# PRELIMINARY SITE PLAN 3200 ROCHESTER ROAD

Site Plan Review

Reviewed for compliance with City Ordinance, Building and Fire Codes. Conditions and mark-ups noted throughout plan set must be addressed prior to final approval.

J2024-0183  
PSP2024-0034  
Revision #2  
Received 1/24/25

SHEET TITLE:  
**STORM WATER MANAGEMENT**

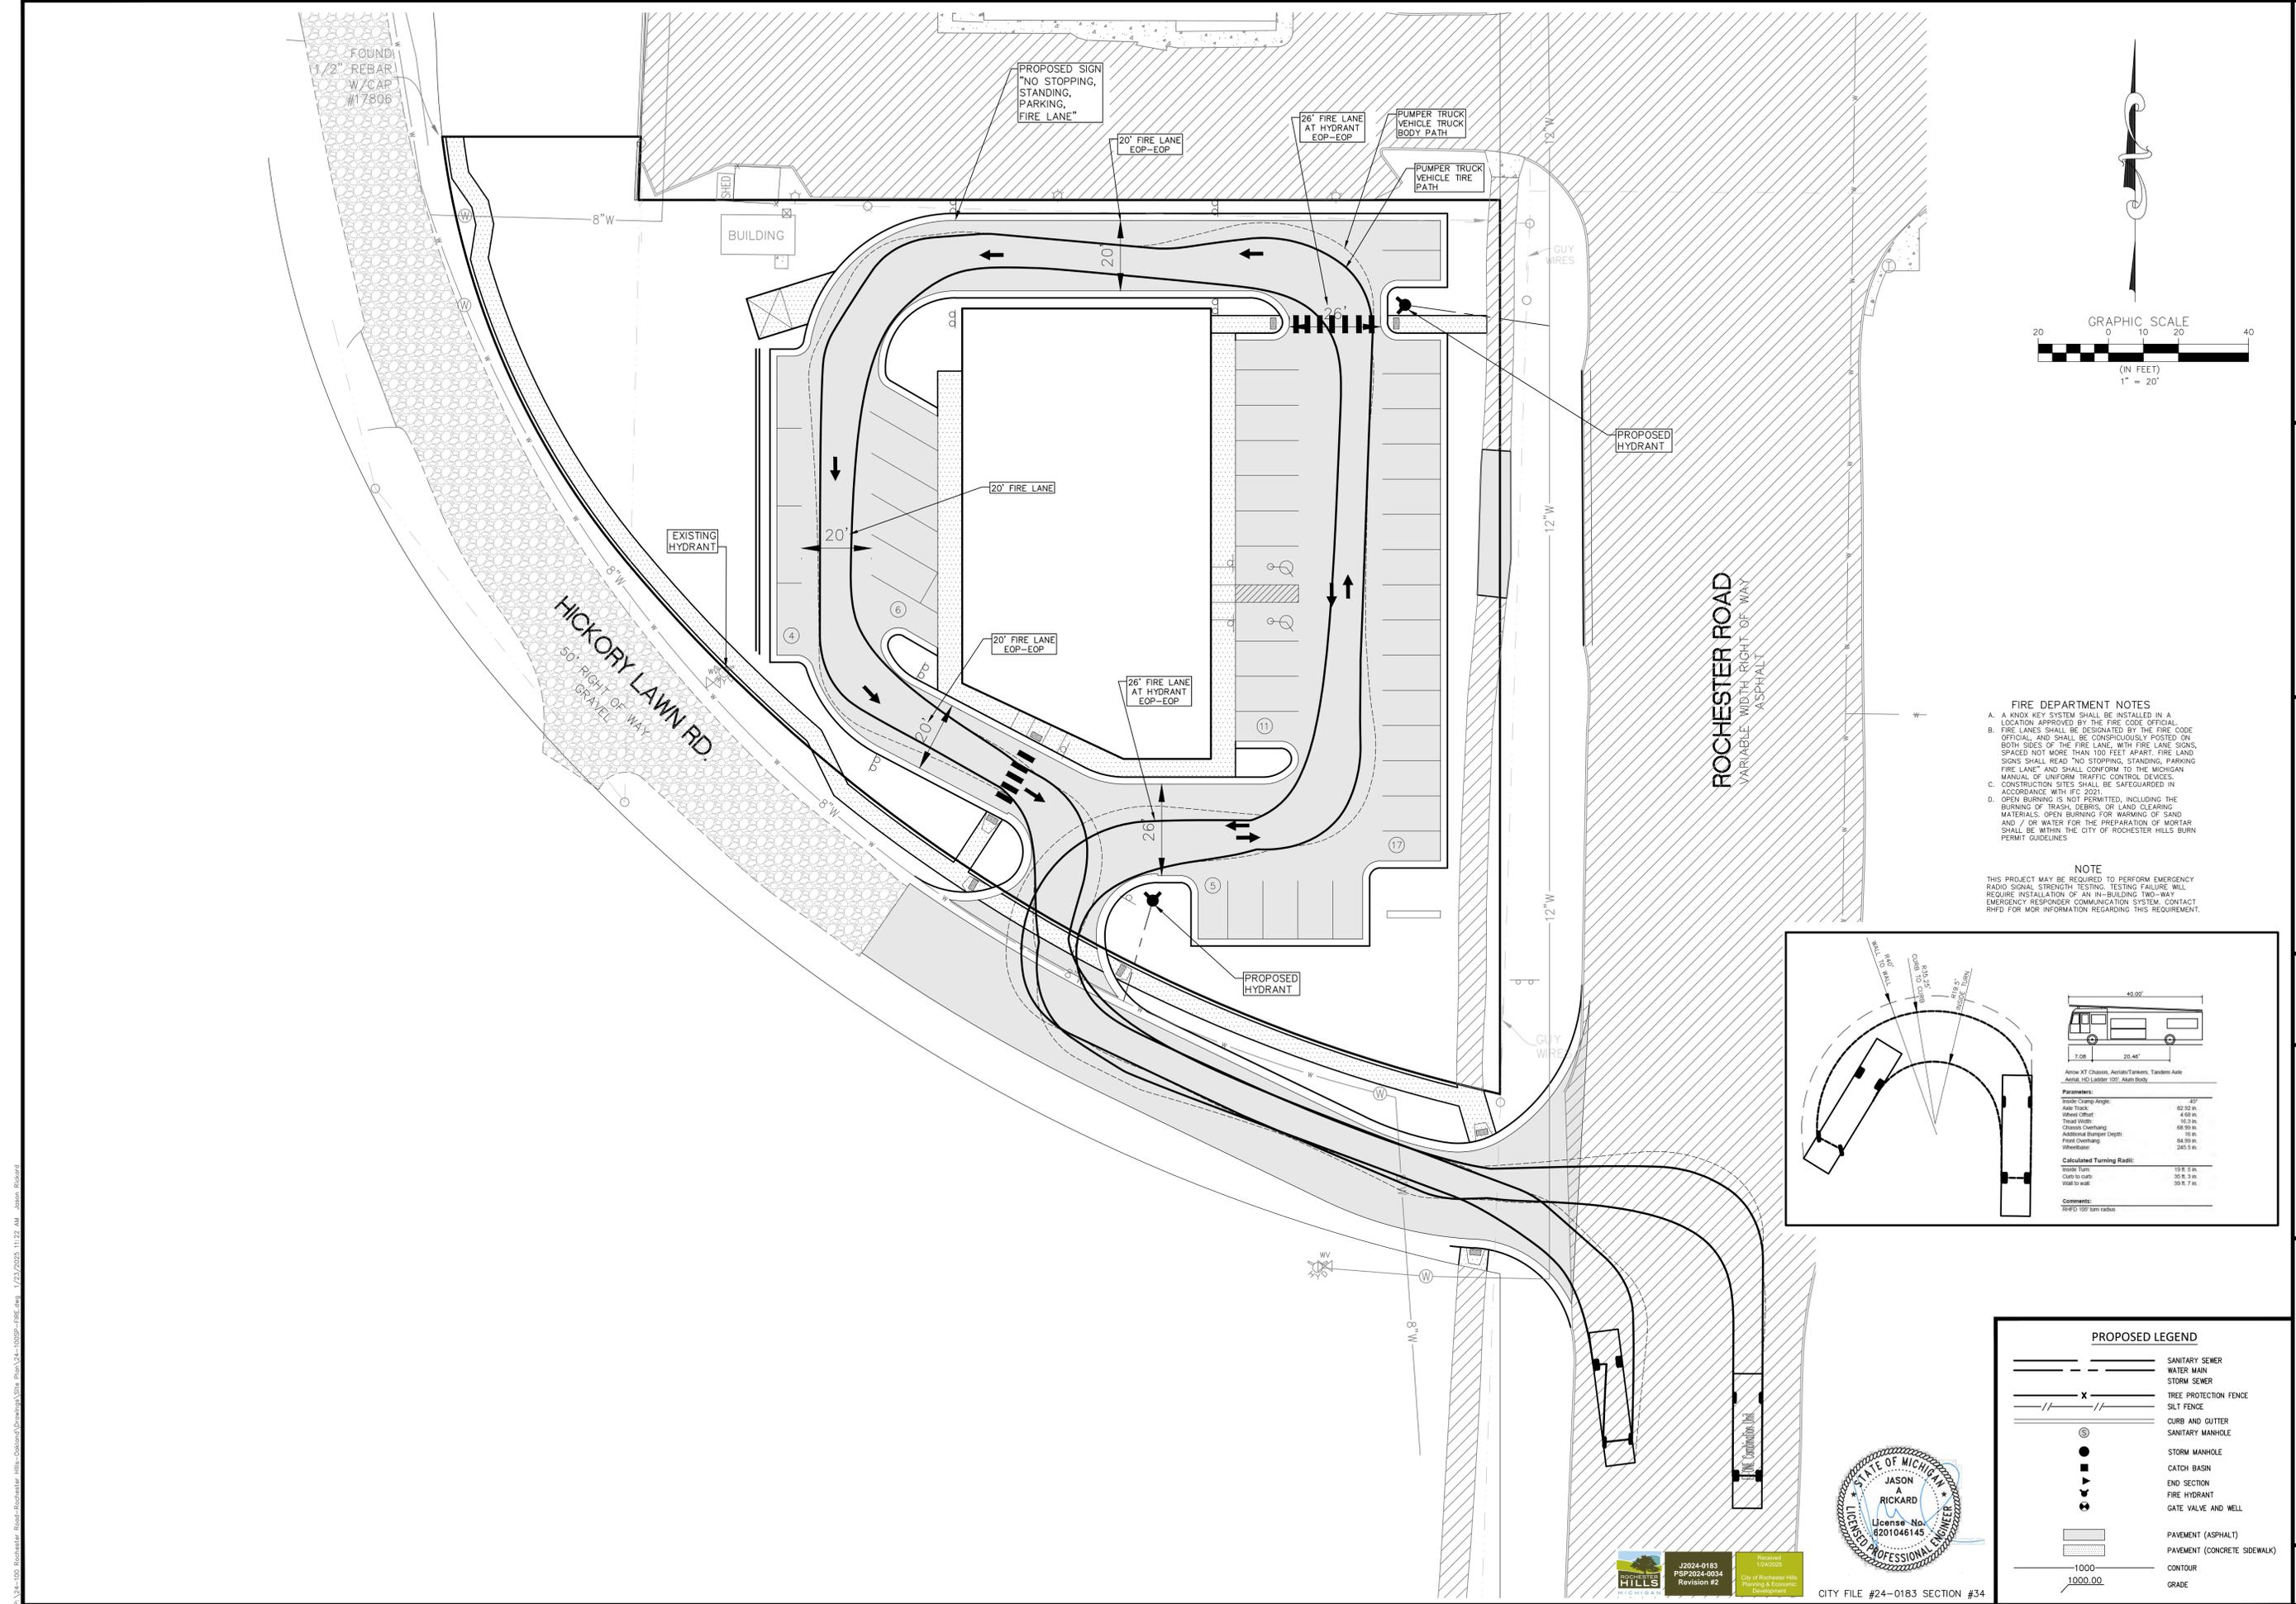
Applicant shall reach out to MDOT to verify whether their agency will need to review and approve the proposed storm drainage connection to the existing structure upstream of their system. Written response from MDOT shall be provided to the City with their decision.

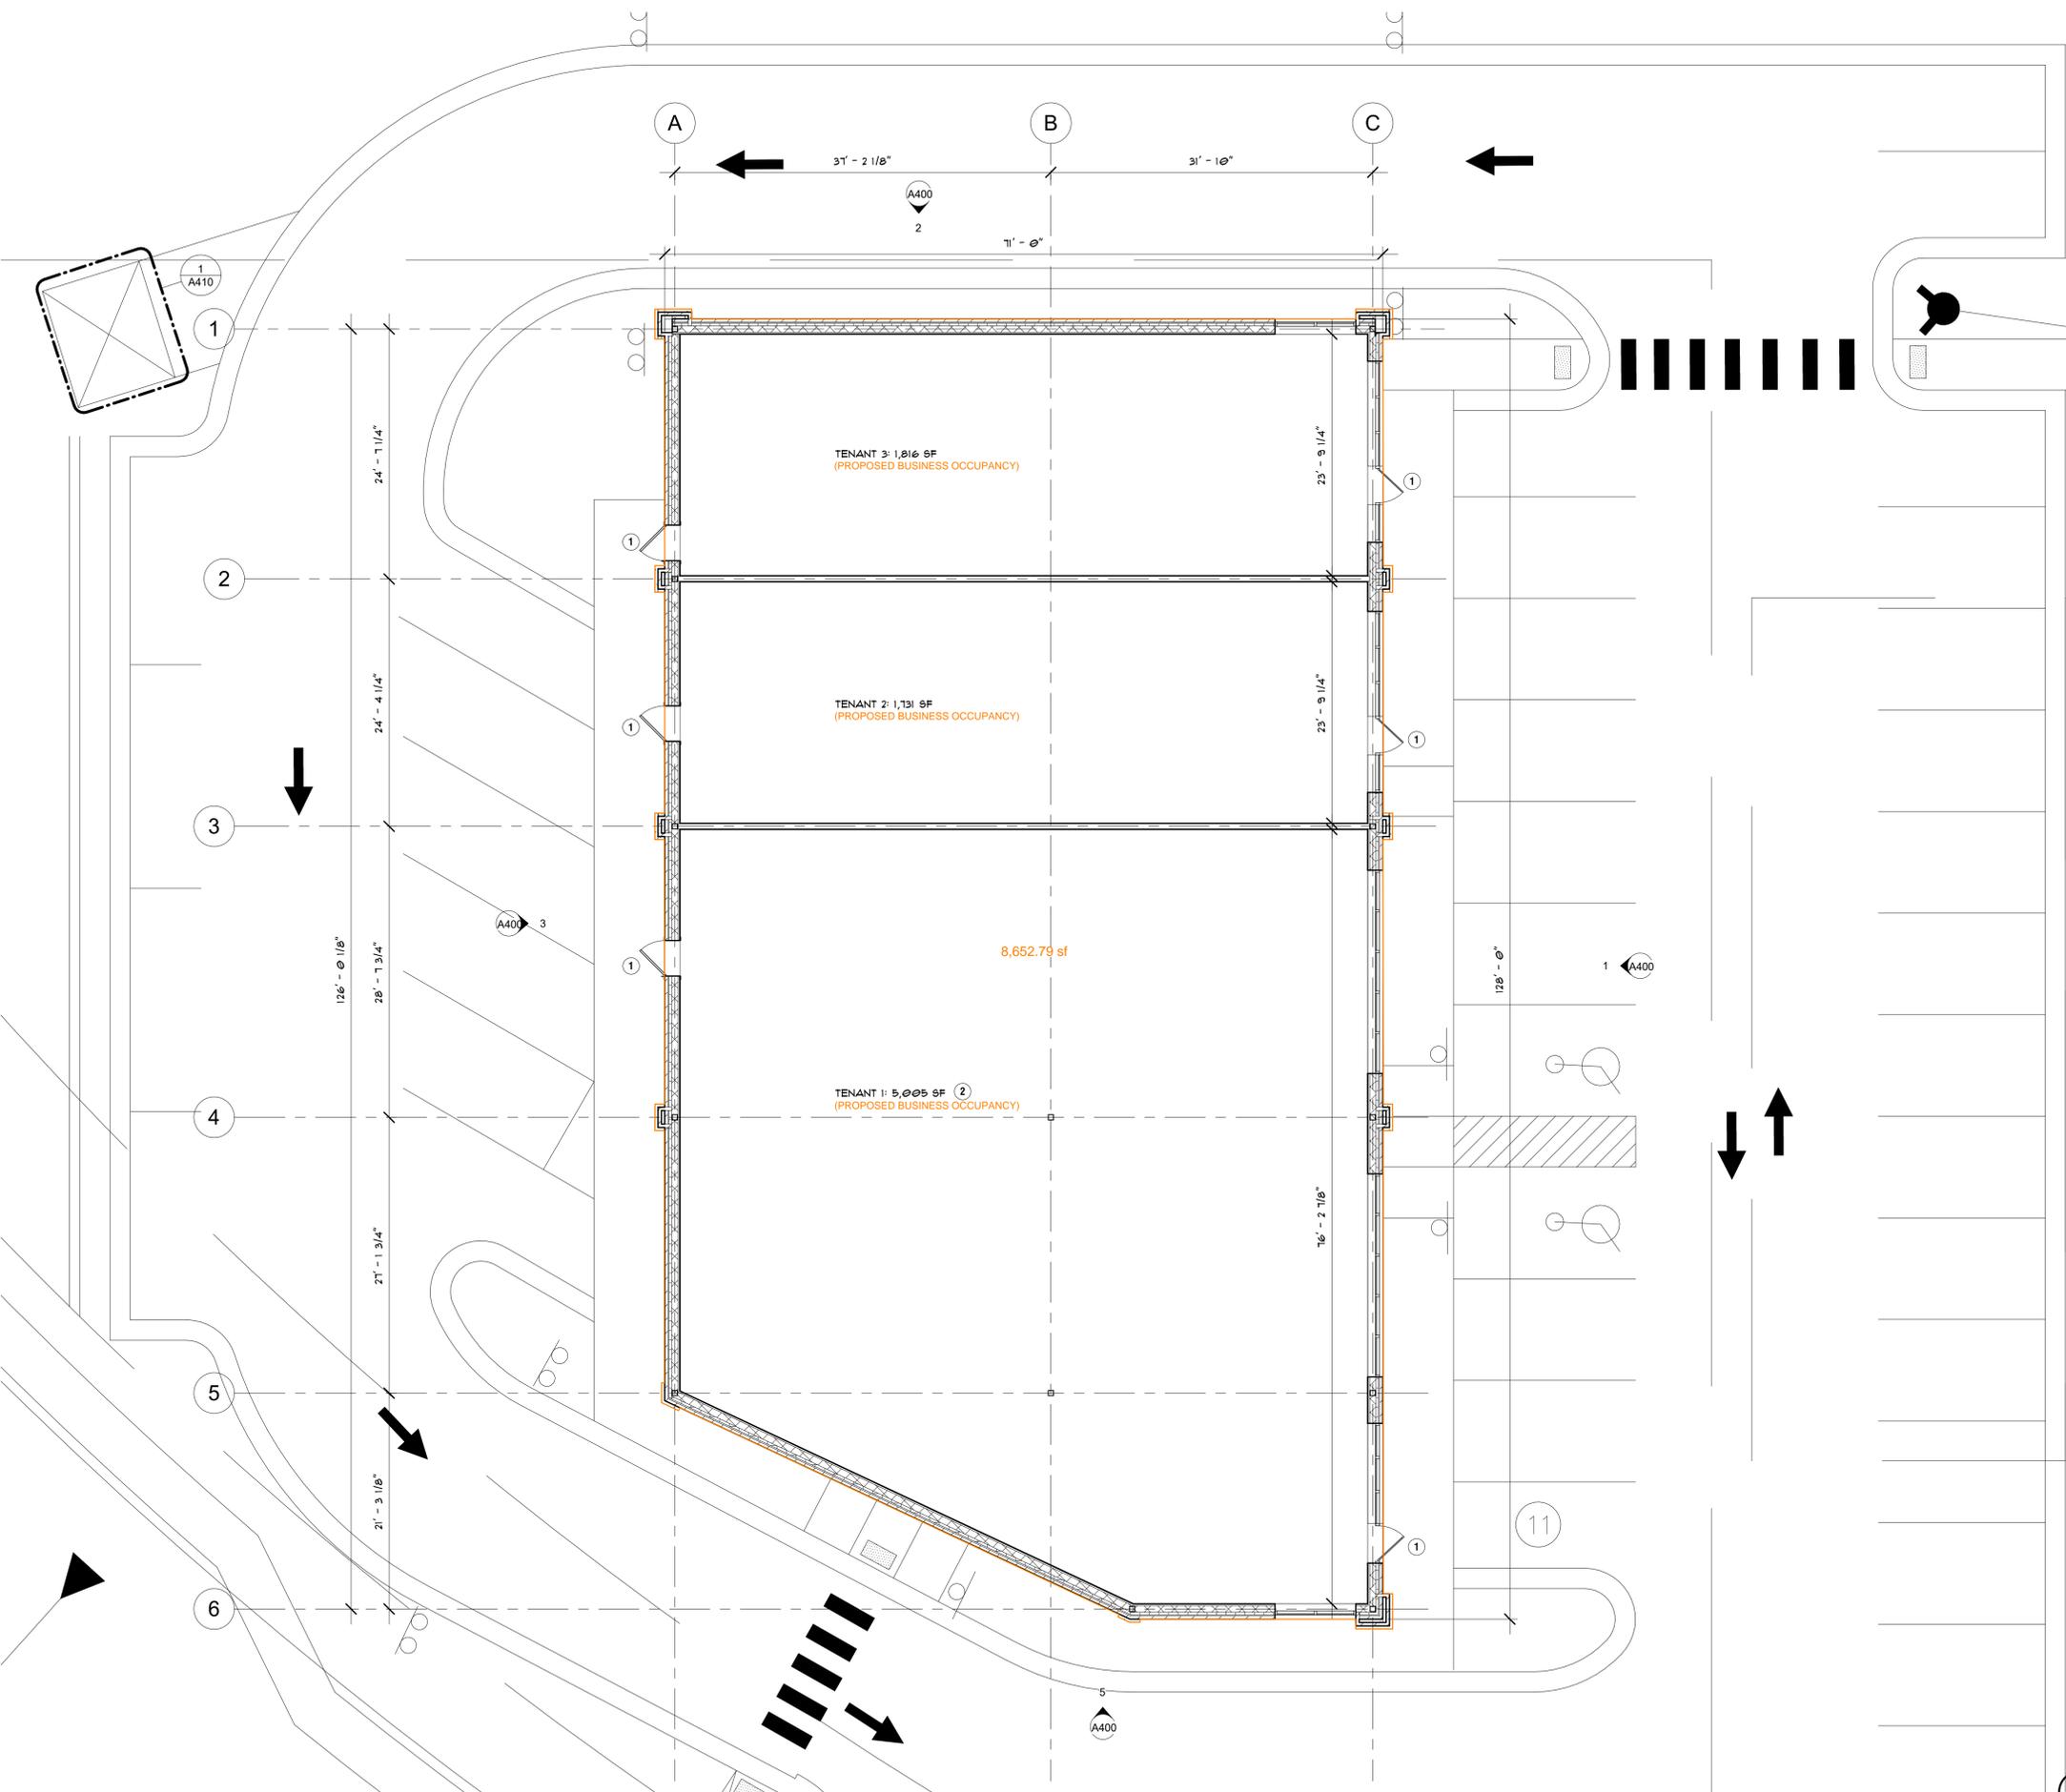
Buffer D requires wall. Planning Commission modification required for fence in lieu of wall.

Irrigation plan to be provided as part of conditions review (if approved)

**Drawing Title**  
**EXTERIOR FACADE MATERIALS**

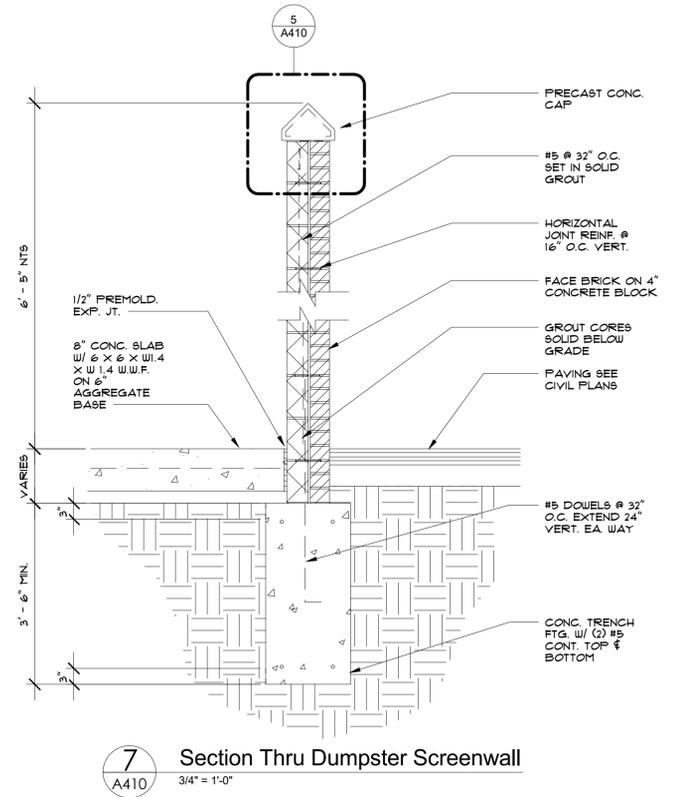
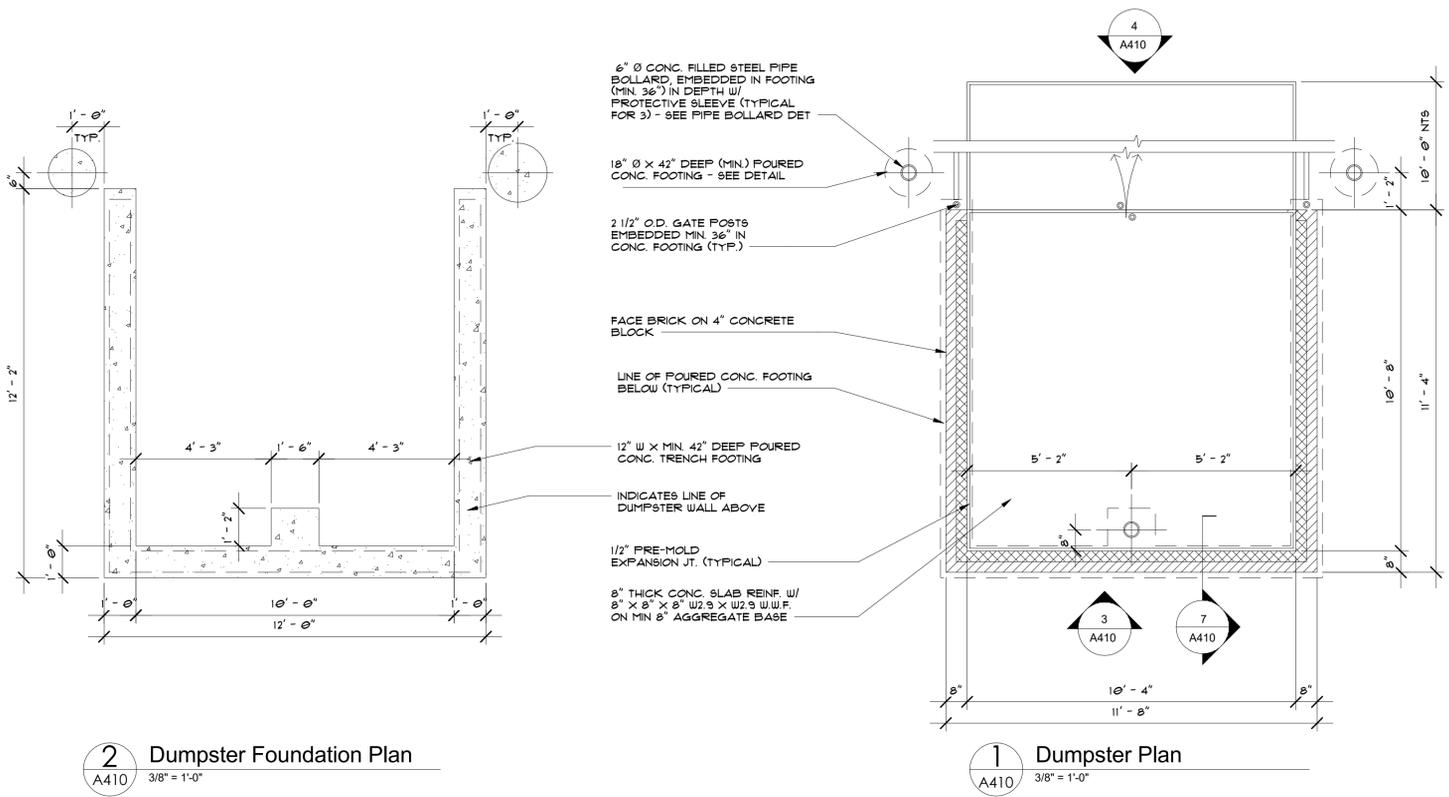
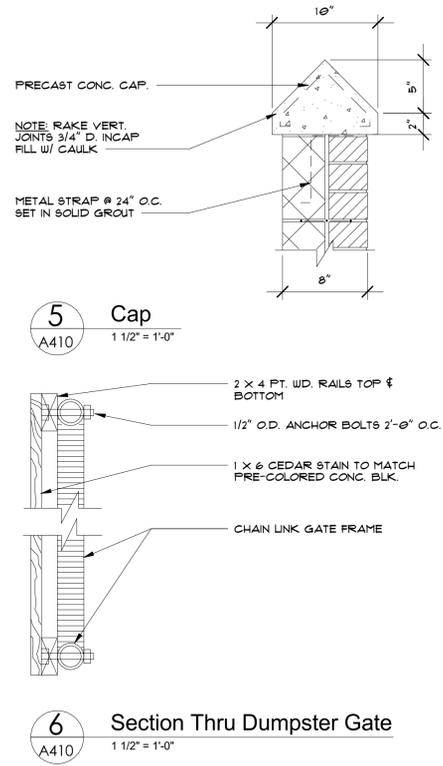
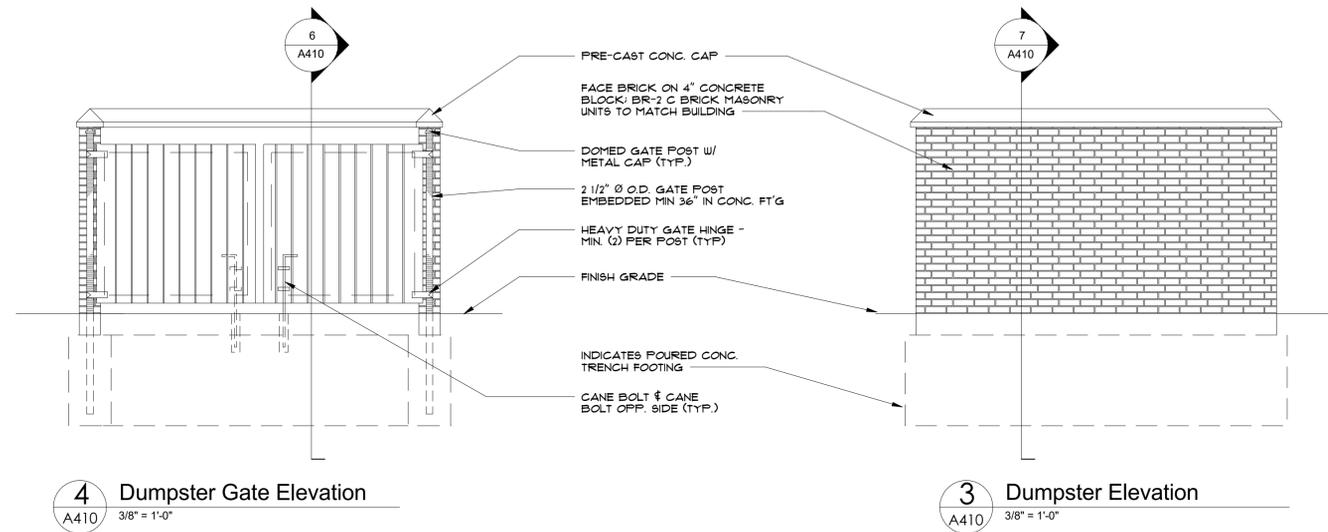
Material types and usage to be reviewed and approved by Planning
